**Addendum No. 2**  
**July 29, 2024**

Project: Brandon Valley Elementary School  
Brandon, South Dakota  
Project #3023

Architect: Architecture Incorporated

## FOOTING AND FOUNDATION PLAN - AREA B

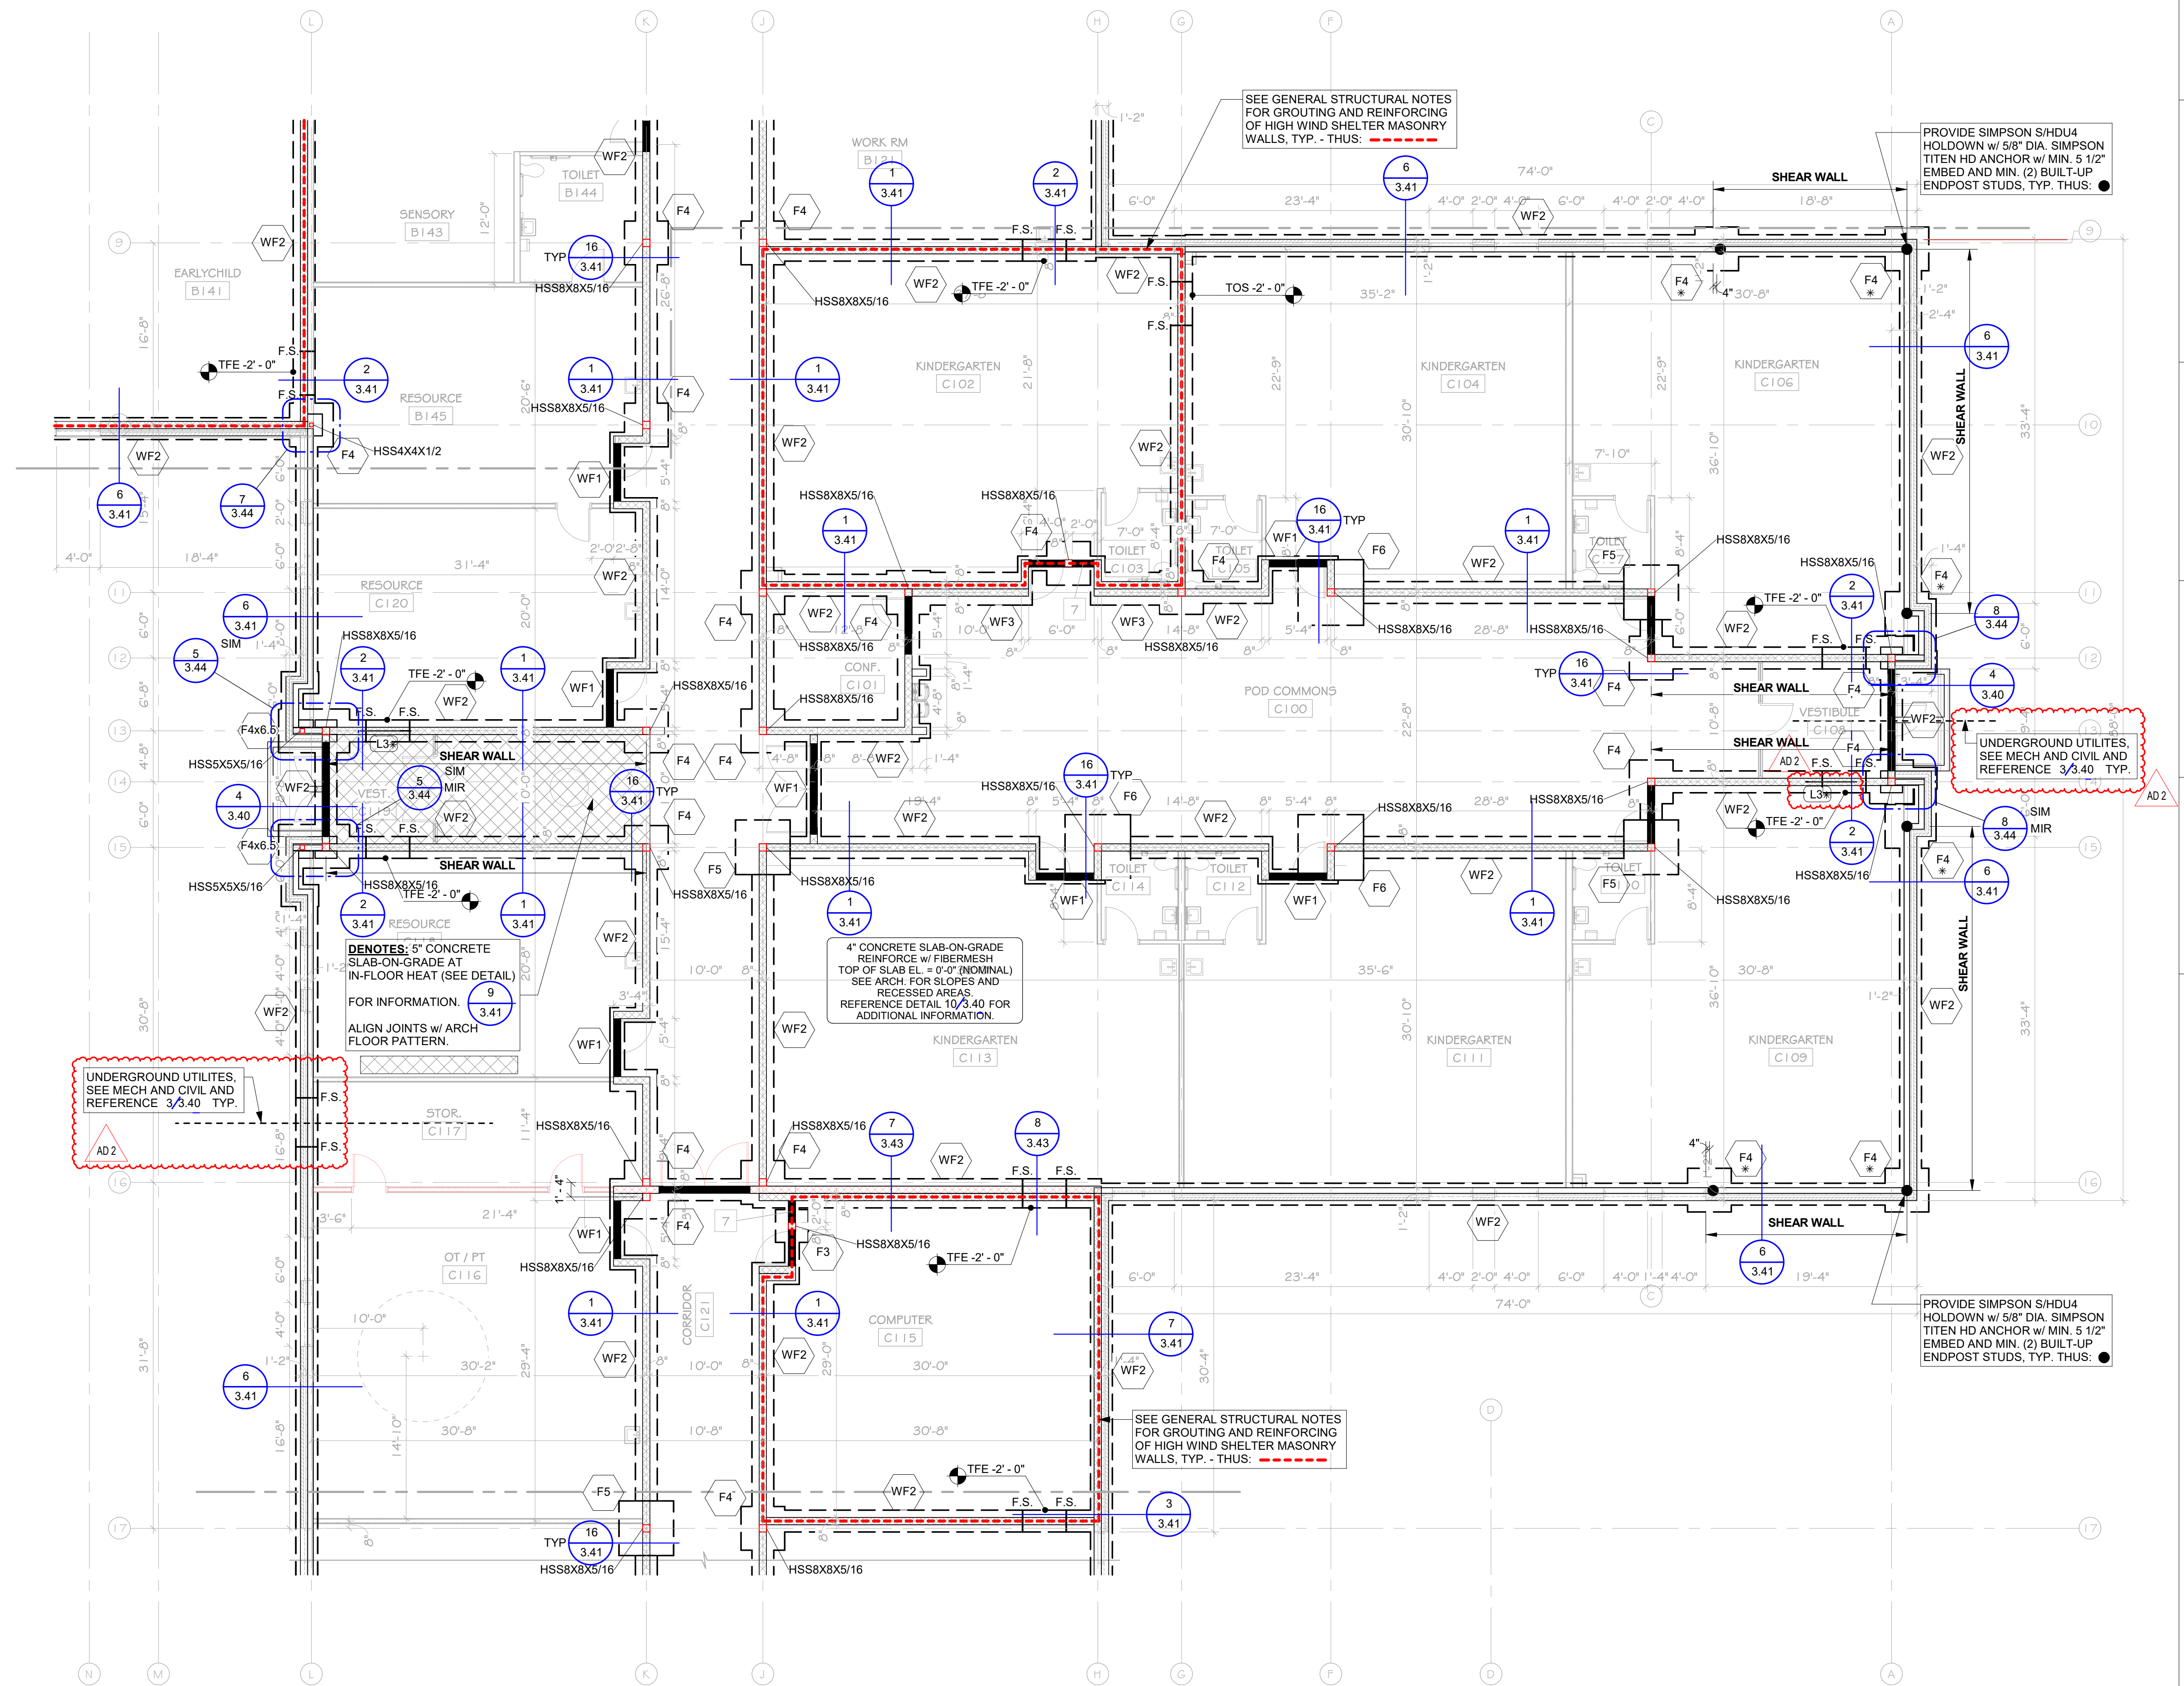
- 19) SHEET 3.12 – FOOTING AND FOUNDATION PLAN – AREA B
  - a) Reference *revised* drawing Sheet 3.12, *revision* dated 7-26-2024, attached to the end of Addendum #2 for the following modifications:
    - i) Reference architectural drawing Sheet 4.40 for slopes to drain at shower locations.

1 FOOTING AND FOUNDATION PLAN - AREA D  
1/8" = 1'-0"

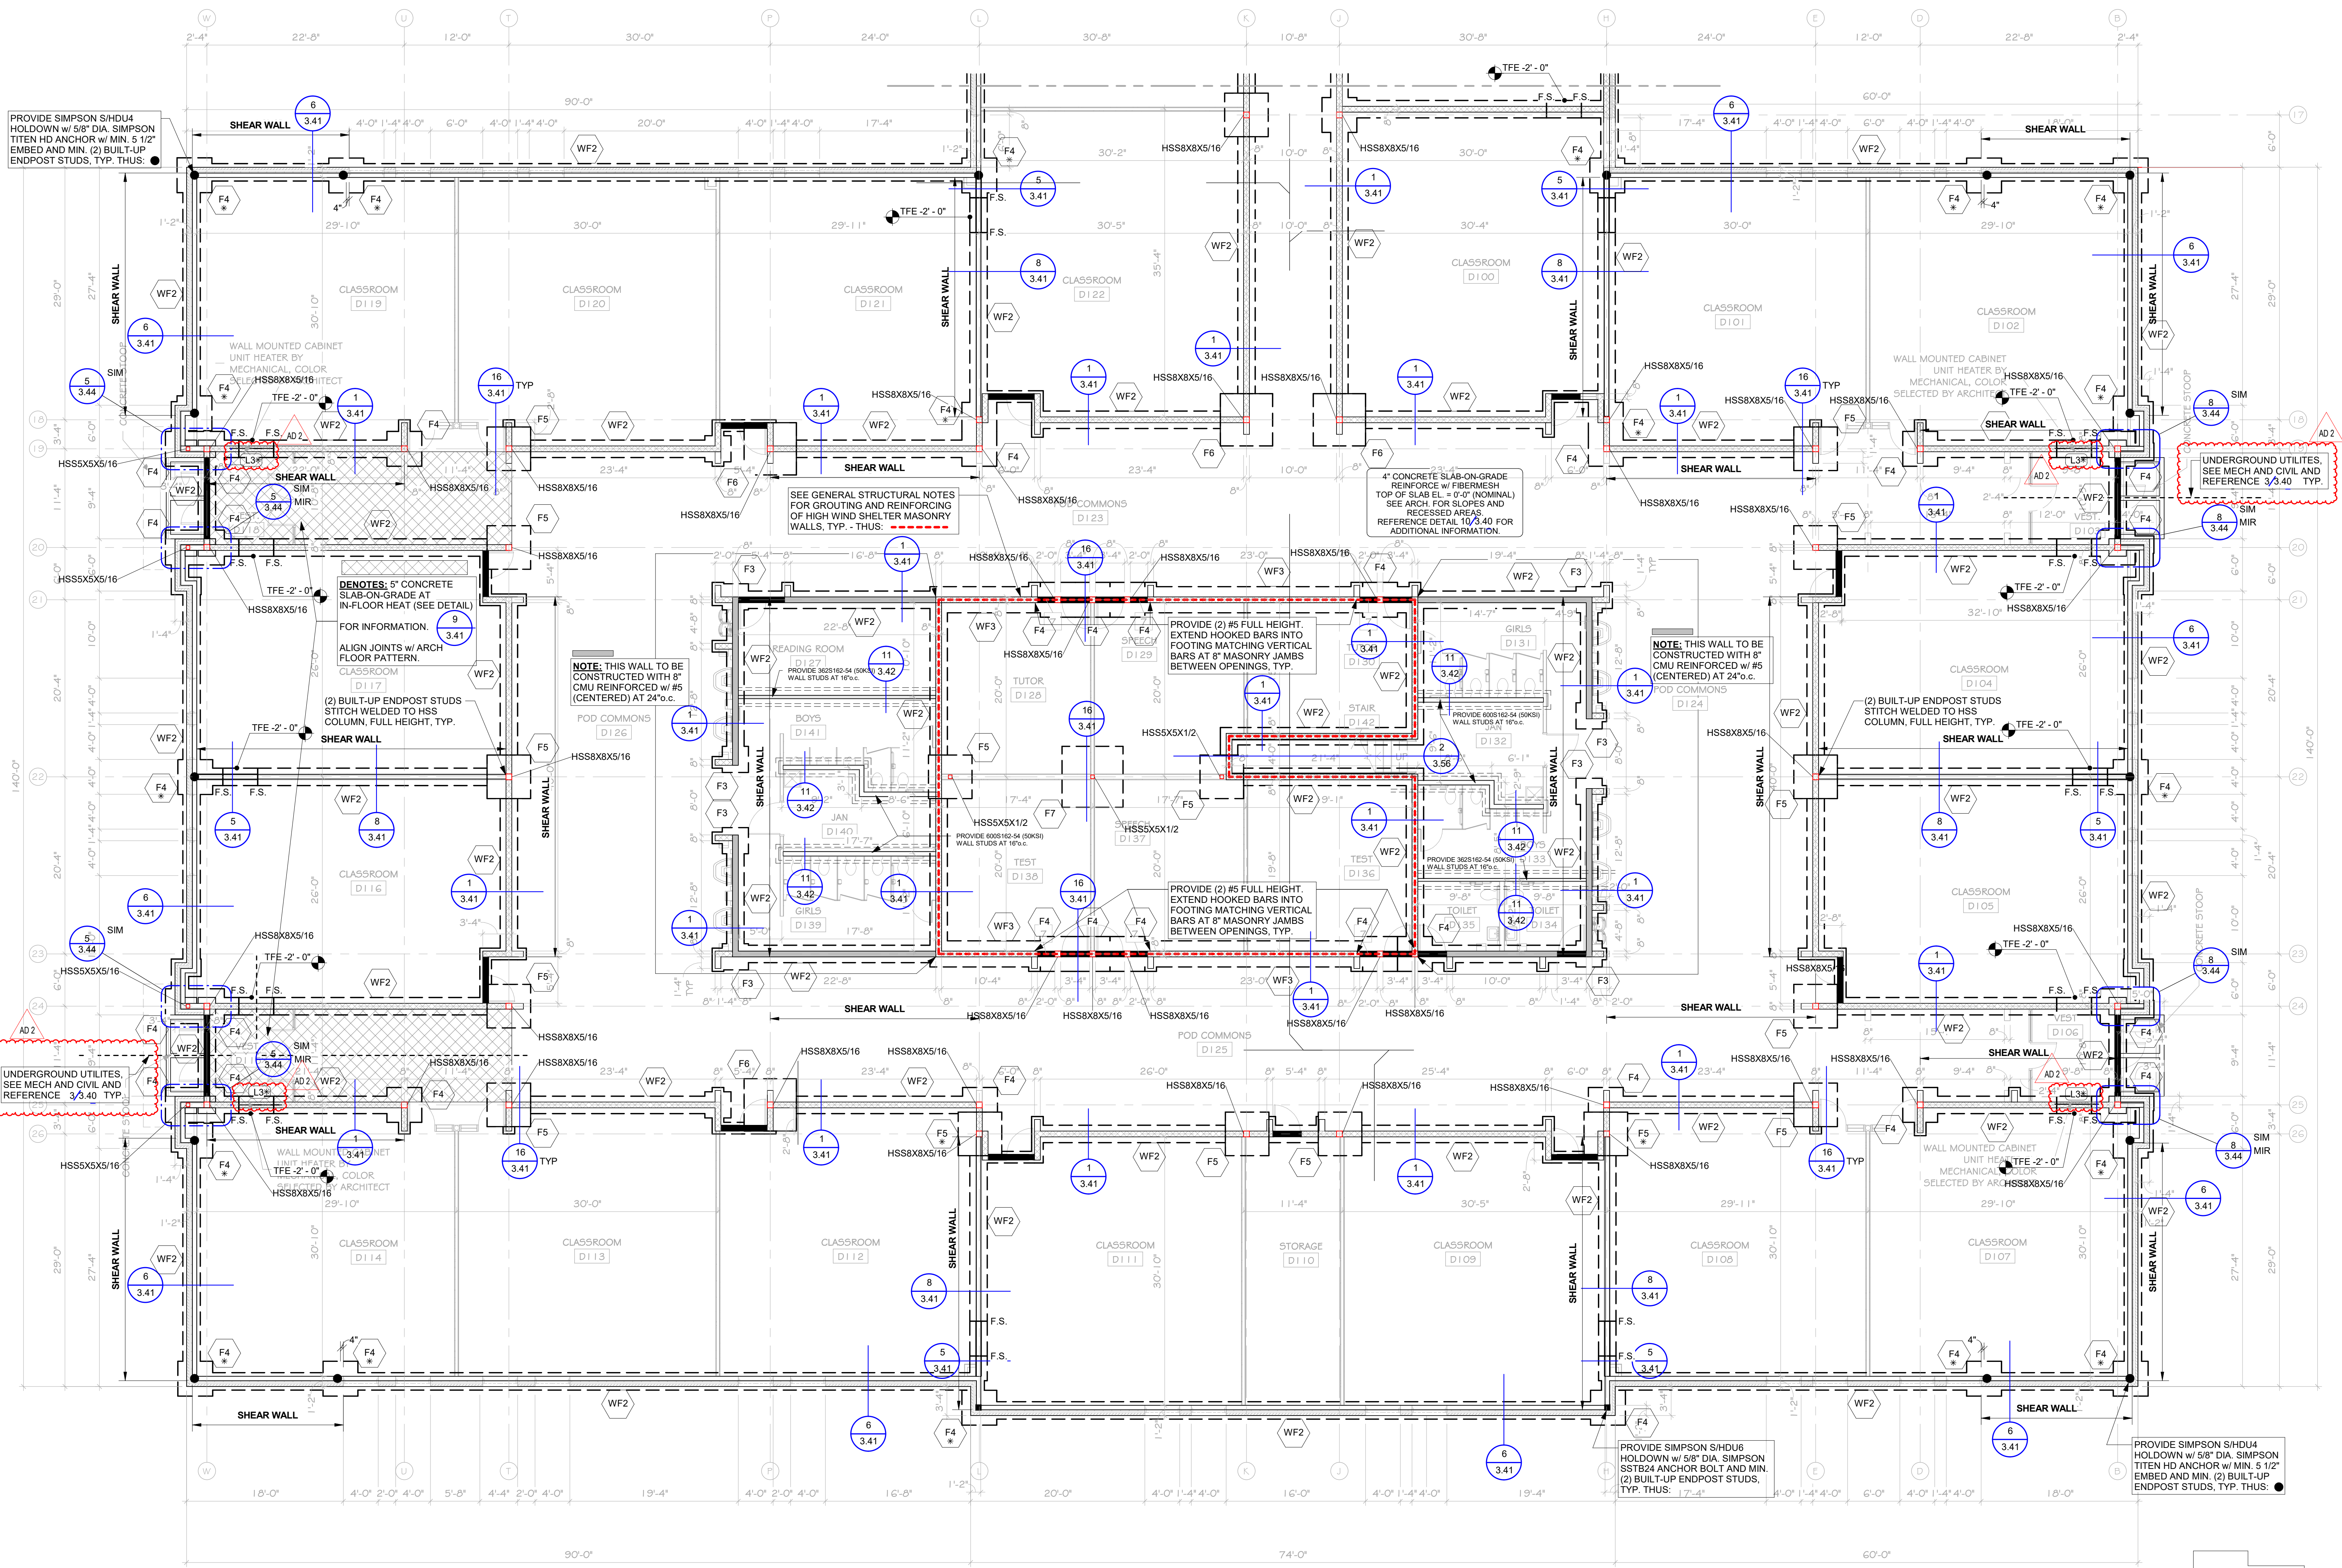
- 21) SHEET 3.14 – FOOTING AND FOUNDATION PLAN – AREA D
  - a) Reference *revised* drawing Sheet 3.14, *revision* dated 7-26-2024, attached to the end of Addendum #2 for the following modifications:
    - i) The Contractor shall be responsible for coordinating underground utility installations at all locations where utility lines enter the building envelope with all subcontractors. Step exterior footings down at utility entrance points as required per the Structural drawings; reference typical detail 3/3.40.
    - ii) Add L3 lintel over all recessed cabinet unit heaters located within CMU walls in vestibules - as indicated.

1 CANOPY PIER AND COLUMN FRAMING DETAIL  
3.43 NTS

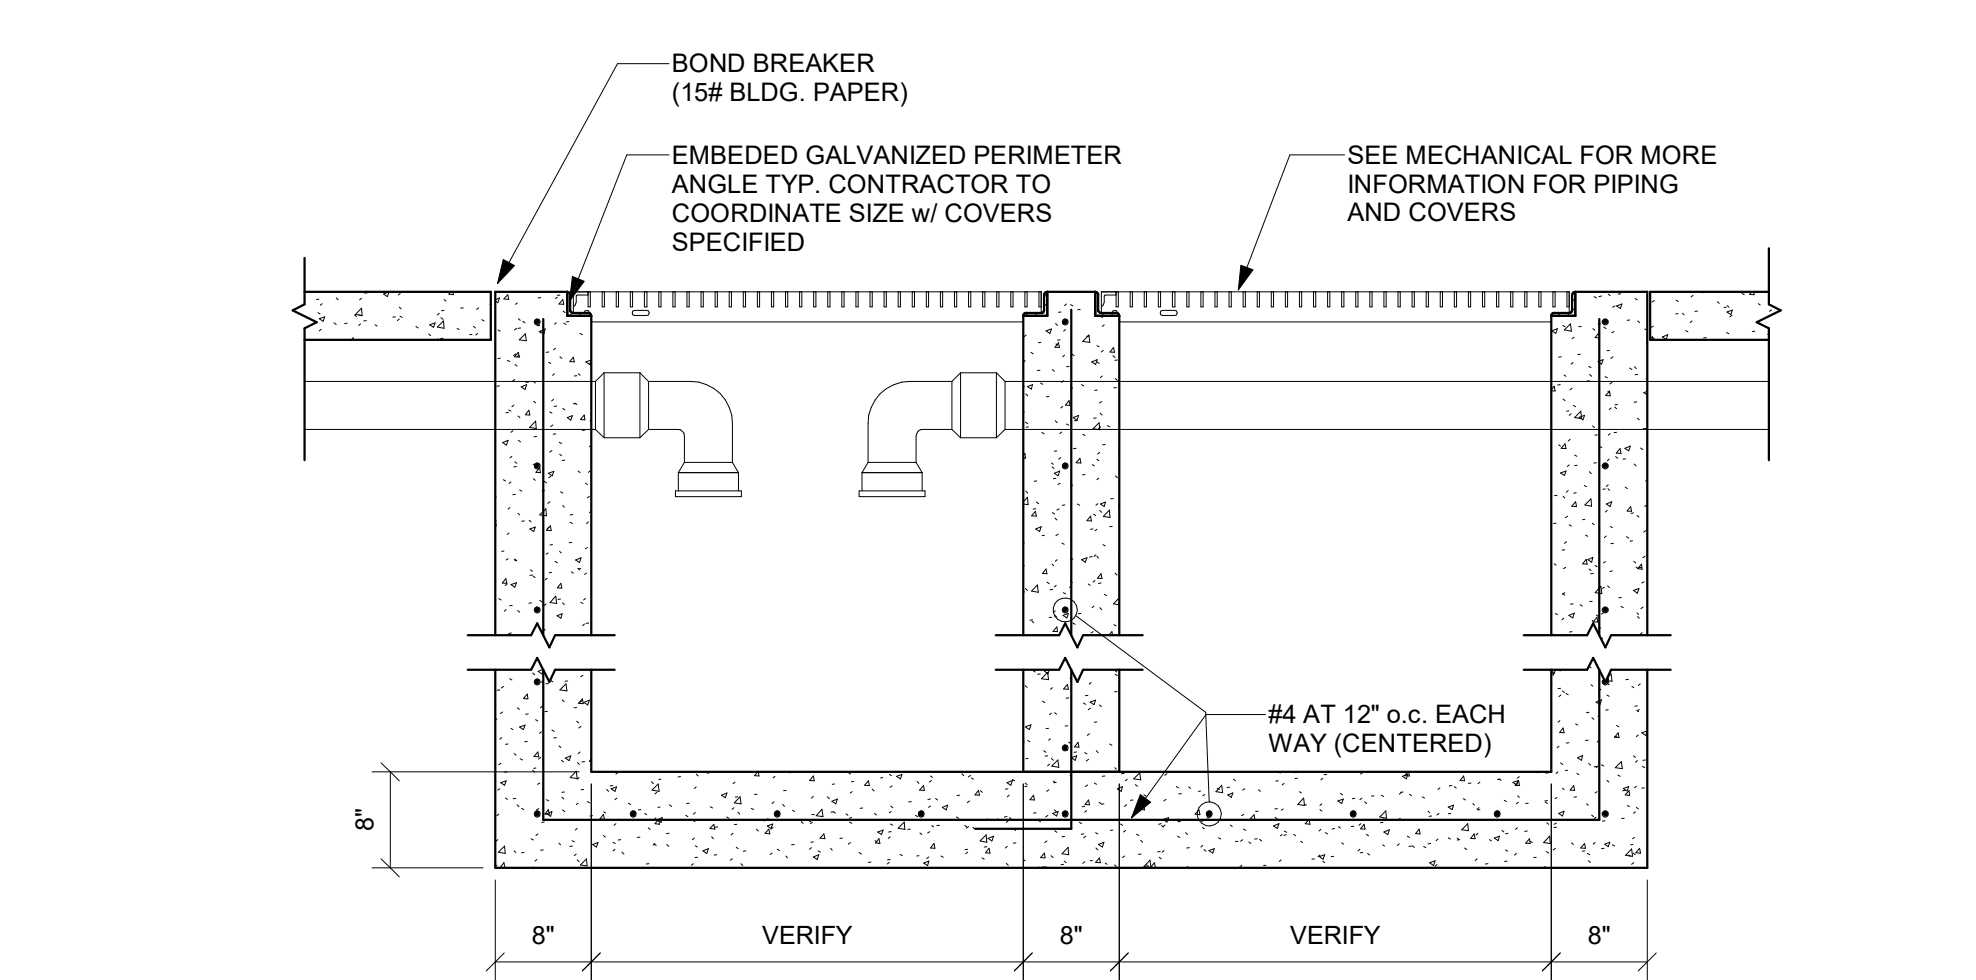
- a) Revise location of steel stud back-up framing at Canopy Columns as indicated in the revised detail 1/3.43; reference *revised* Sheet 3.43, *revision* dated 7-26-2024, attached to the end of Addendum #2.
